BT09-019

SUNROOF WIND NOISE

APPLIED VEHICLES: M35 / 45 (Y50)
 G35 / 37 Sedan (V36)
 G37 Coupe (CV36)
 FX35 / 50 (S51)
 EX35 (J50)

Figure 1

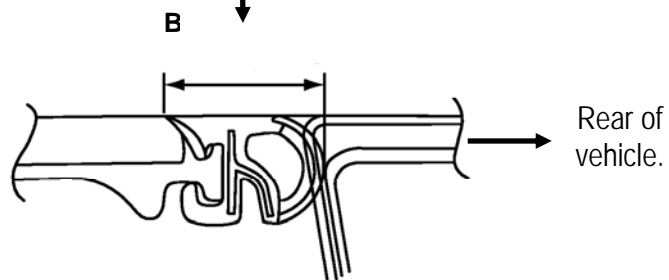
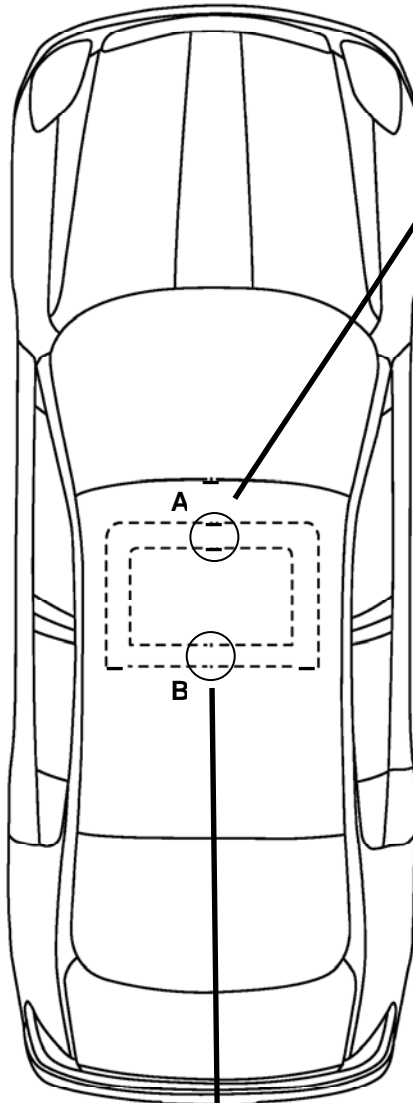
1. Clean the Sunroof Glass Lid Assembly (glass lid) seal and sunroof opening edge.
 - Use isopropyl alcohol or suitable cleaner.
2. Inspect the fit of the glass lid. Adjust as needed (refer to Figure 1 on page 3, and Figure 2 on page 4).
 - Use the appropriate ESM as needed.
 - The front of the glass lid should be flush but no more than 0.5 mm below the roof surface.
 - The rear of the glass lid should be flush but no more than 0.5 mm above the roof surface.
 - The difference in the glass lid's front-to-rear gaps should be no greater than 1 mm.

Measure gaps at A and B.

TARGET: Difference no greater than 1 mm.
